Greg F. Rawl, P.G.

November 3, 2006

Re: Review of WRS Report titled "Lee County Utilities Supporting
Documentation for the Wellfield Protection Ordinance Update"

Corkscrew Water Treatment Plant, Adjacent Wellfield & WRS Delineated Surficial Aquifer Wellfield Protection Zones

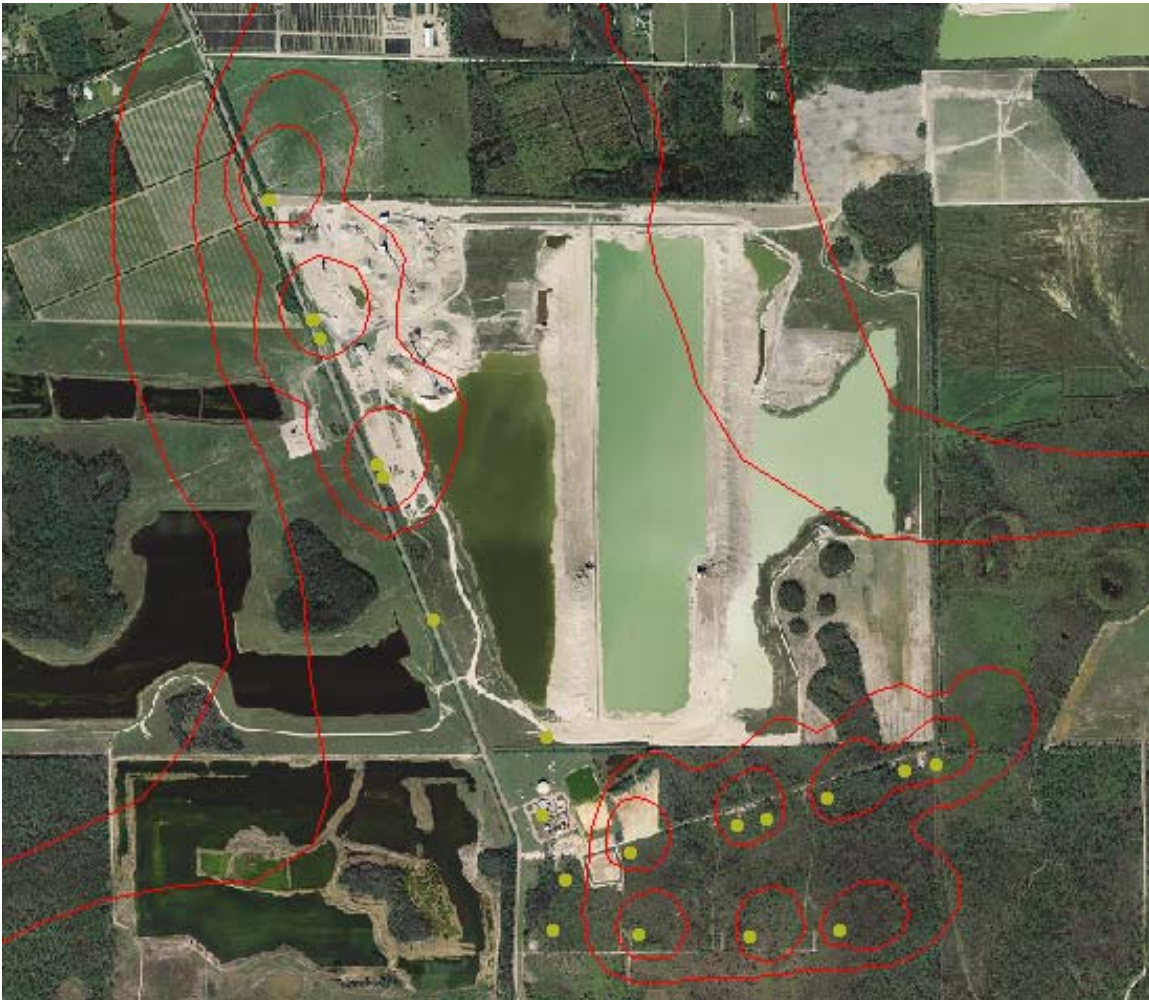
Inserted below, on the next page, is a figure that was created by overlaying the results of the WRS modeling contours on top of aerial photographs taken last year. The WRS Surficial Aquifer Wellfield Protection Zone Contours are shown in red and the light green circles indicate the locations of various wellheads. The innermost travel contour is the six month travel time, followed by the one year, five year and finally the ten year as you move radially away from the well head. The area covered in the figure is approximately four square miles in size. The travel time contours that delineate the various zones that are shown in the figure would look totally different if the mine pits were simulated in the model. In a realistic

simulation the travel time contours are drawn or elongated towards the mine pits and would not be as aerially extensive as the ones projected by WRS. In the example below, only one pit is included in either the six month or one year travel time zones. However if it were realistically conceptualized and simulated, at least half of the pits shown below would be in either the six month or one year travel time zone. Furthermore, pits when intersected should be assumed to be entirely within the appropriate travel time zone, as a result of the mixing within surface water bodies. Also the active pit shown below will ultimately retain a configuration with the interconnection of the various pits in keeping with their mining permit from the County. This should also be factored into the zone delineation.
